# Wisconsin Department of Transportation

**Proposal #14: 2025-13-71, WISC 2017 103  
Capitol Drive Village and City of Pewaukee  
Five Fields Road to Wethersfield Road  
STH 190  
Waukesha County**

This is Addendum No. 01, which provides for the following:

STRUCTURE B-67-331  
CROSS SECTION  
AND QUANTITIES  
SHEET 2 OF 20  
466

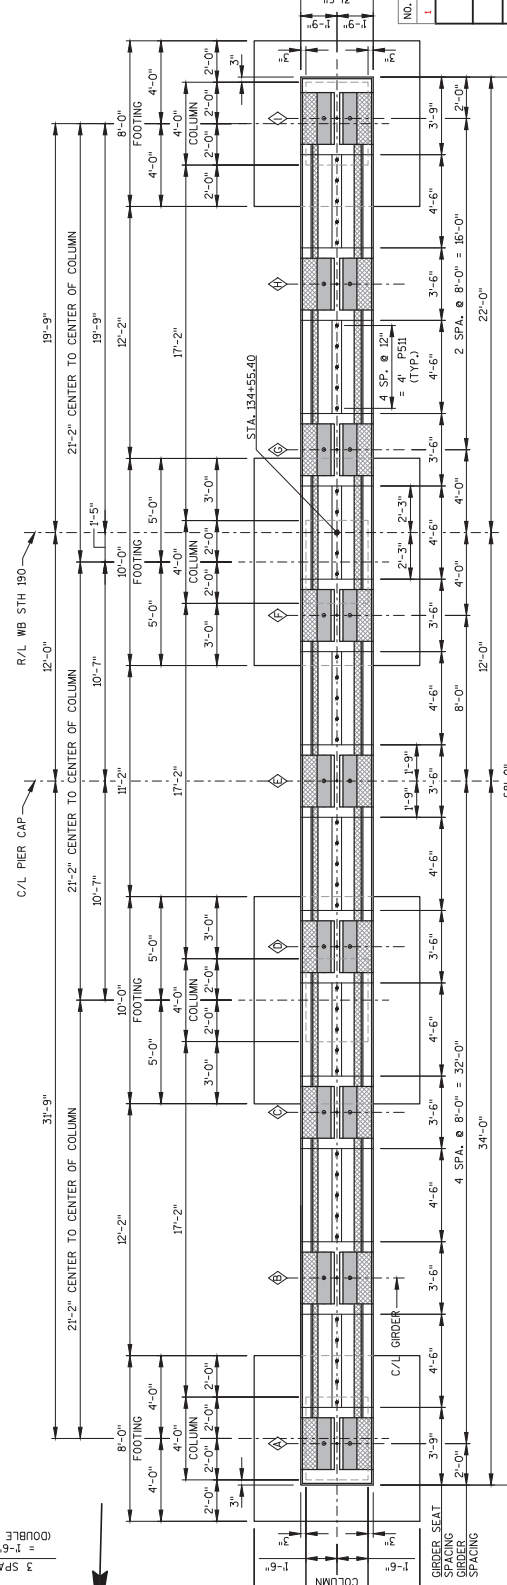
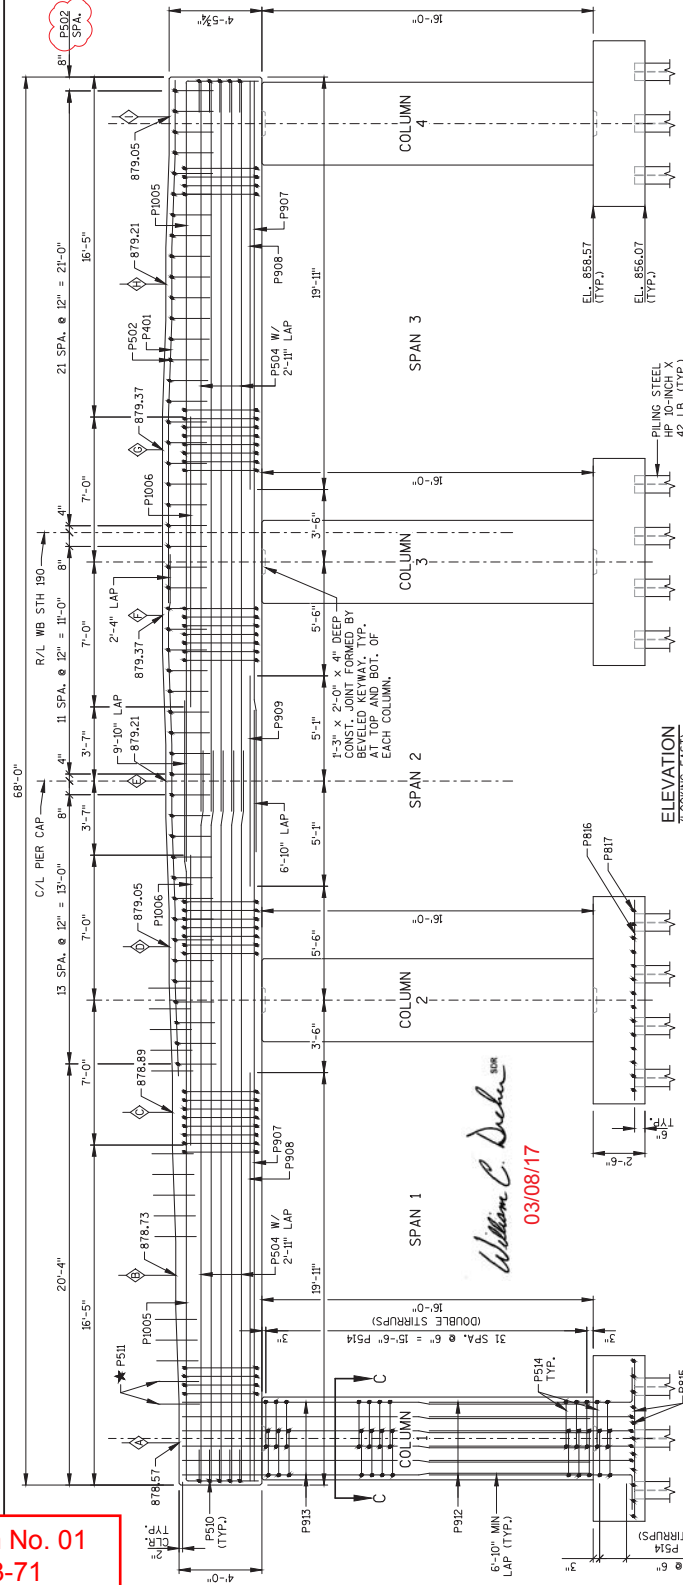
Revised Plan Sheets	
Plan Sheet	Plan Sheet Title (brief description of changes to sheet)
465	Moved name plate location, added removing concrete slope paving note
466	Changes to Total Estimated Quantities Table
474	Added note for spacing of P502 bars
477	Changed concrete strength units to ksi
481	Changes to Parapet Bill of Bars
482	Changes to Approach Slab Bill of Bars
483	Added minimum lap note to bar R508
485	Added removing concrete slope paving note
486	Changes to Total Estimated Quantities Table
493	Changes to notes on East Abutment Bill of Bars
494	Added note for spacing of P502 bars

REVISION  
1 3/9/2017 ADD REMAINING QUANTITY OF SLOPE PAVING QUANTITIES TO SHEET 2 OF 20

CROSS SECTION  
 AND QUANTITIES

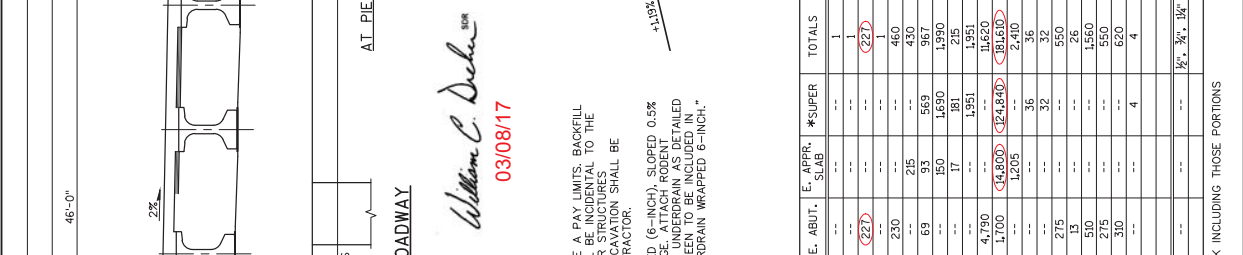
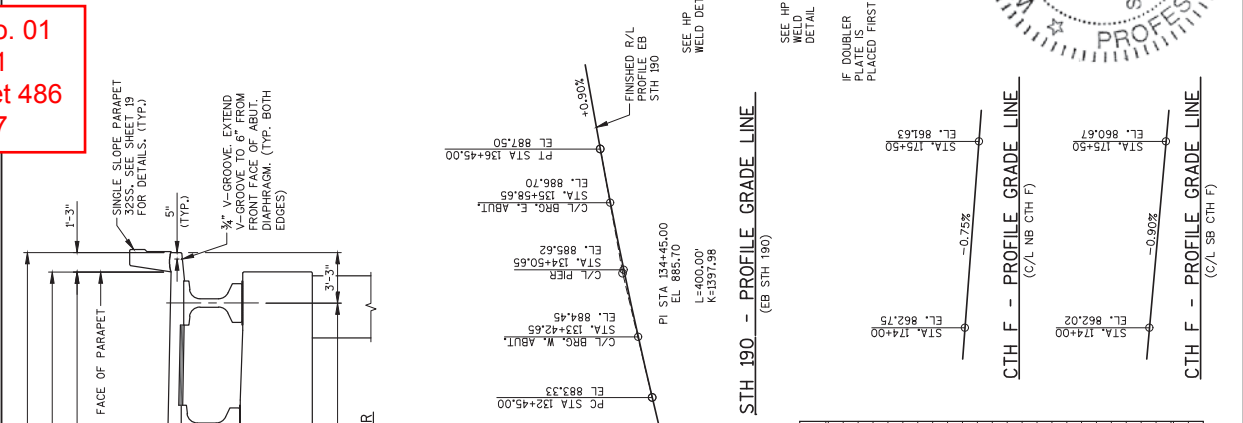
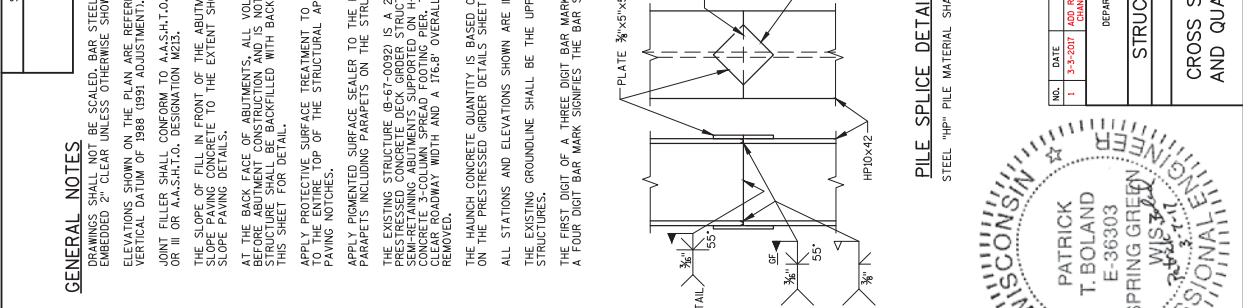
NO. DATE REVISION  
 1 3-9-2011 ASB REMOVAL OF EXISTING HAUNCH COATED BAR STEEL QUANTITY P/B  
 STATE OF WISCONSIN  
 DEPARTMENT OF TRANSPORTATION

EAST ABUTMENT  
 DETAILS

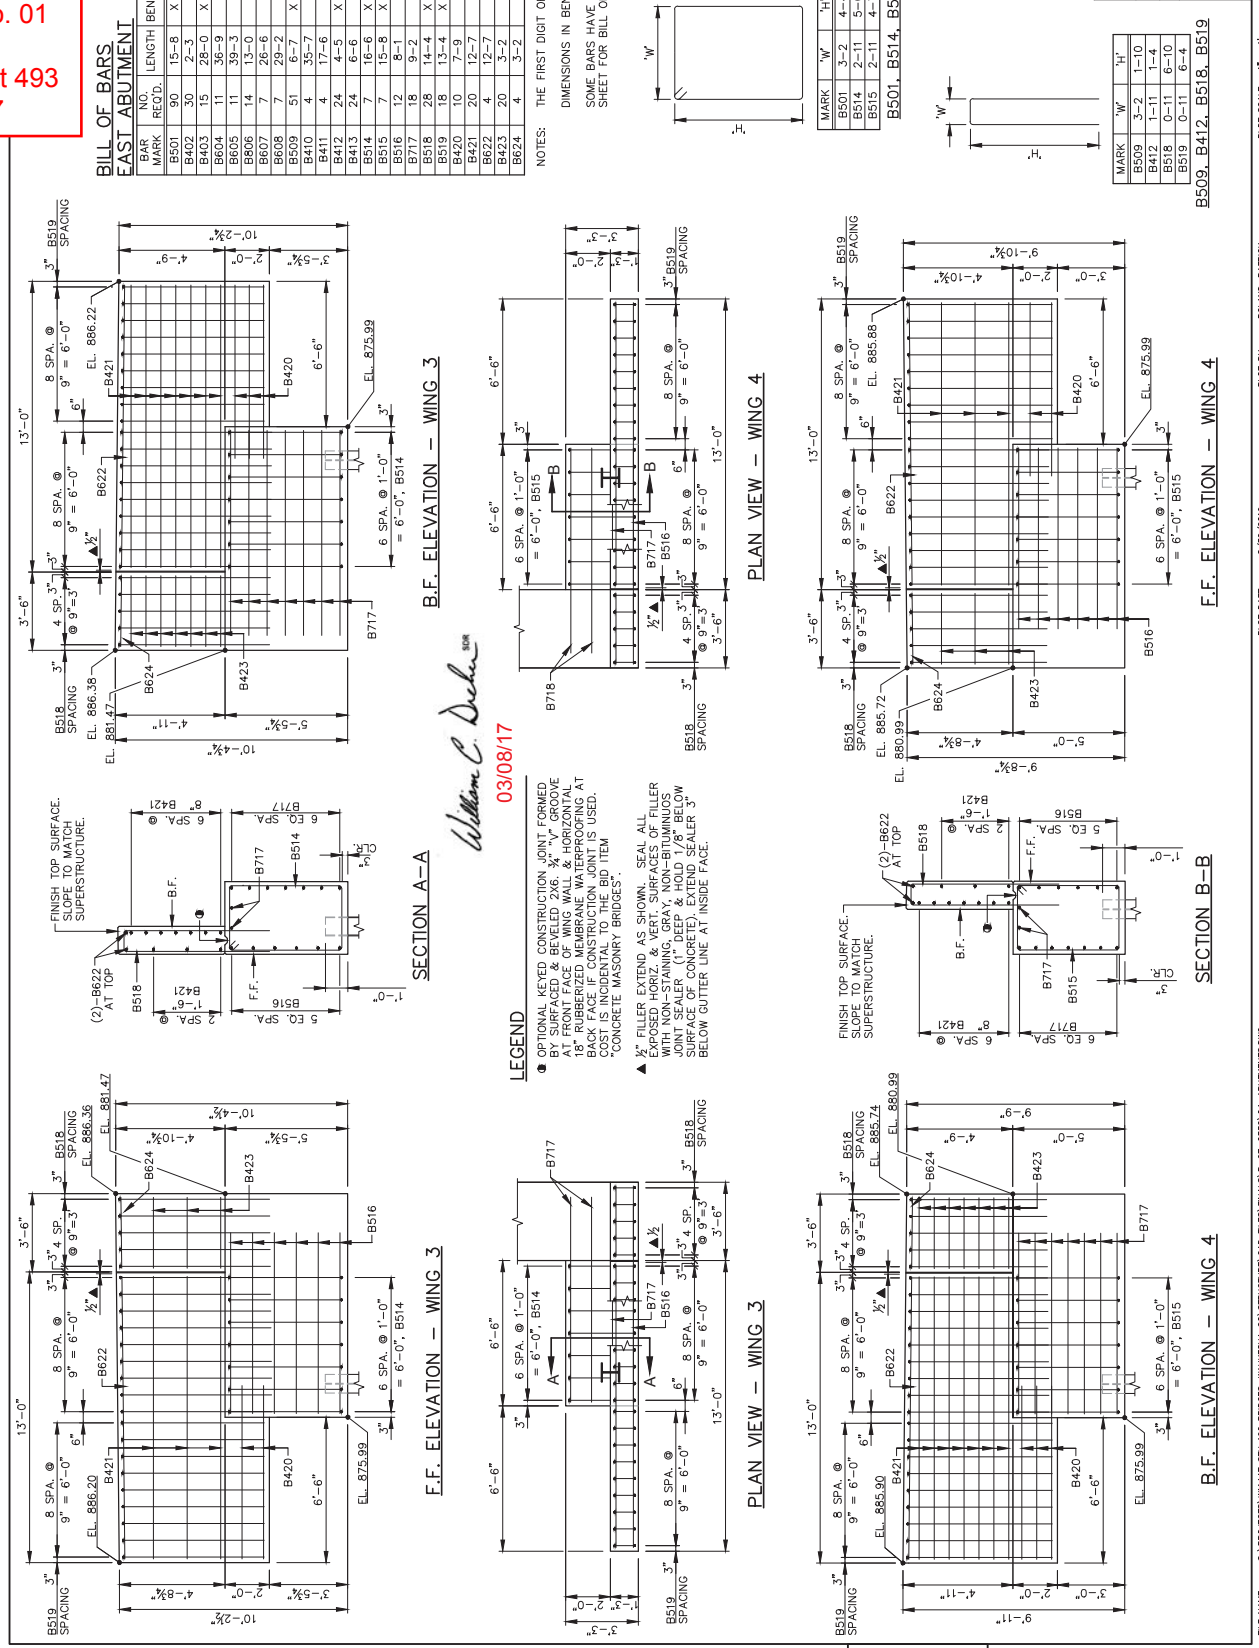
NO.	DATE	REVISION	BY
1	3-3-2017	BILL OF BARS, LOCATIONS	PTB

APPROACH SLAB

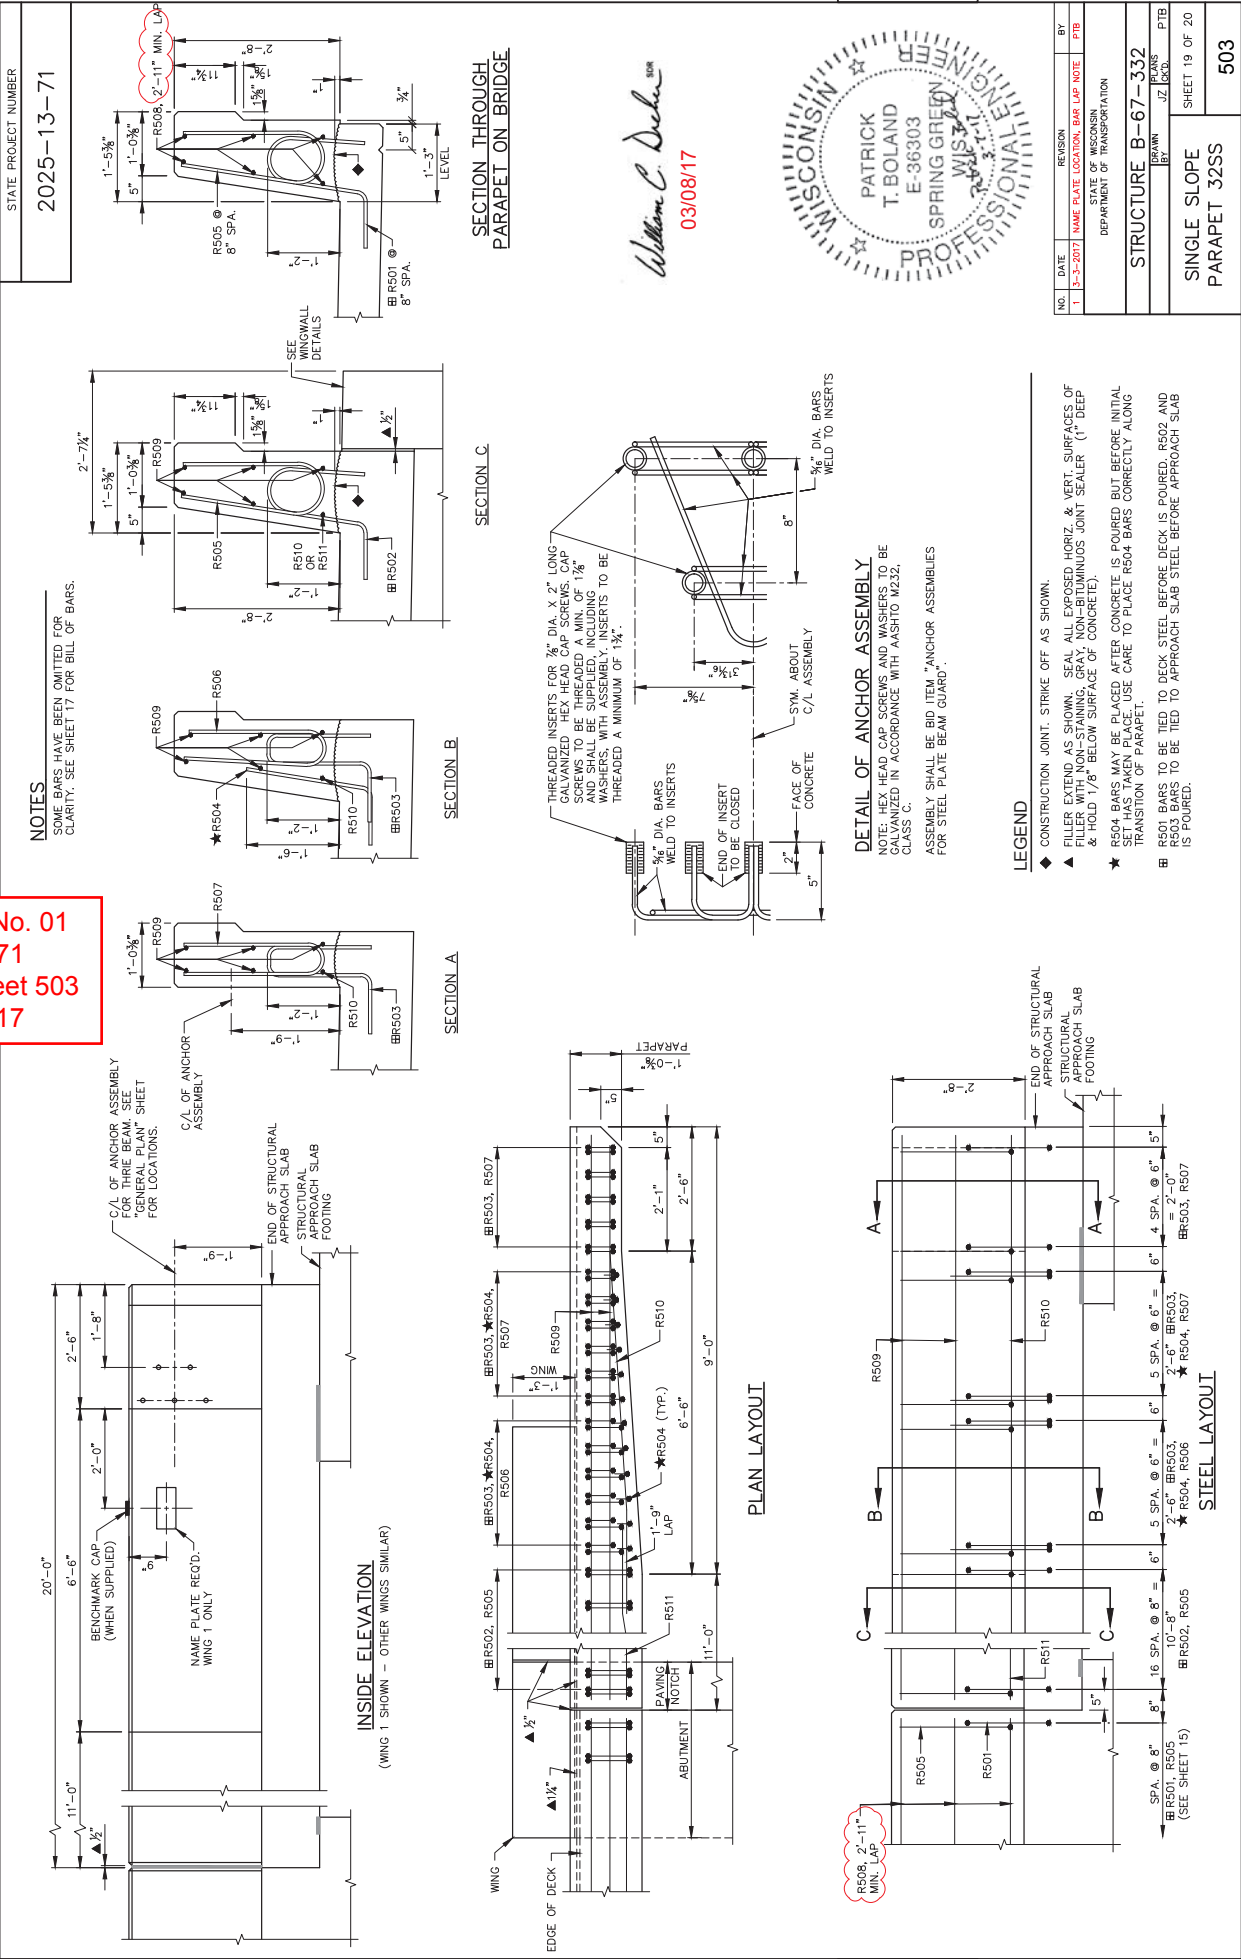
NO.	DATE	REVISION	BY
1	3-3-2017	BAR LENGTH	PTB
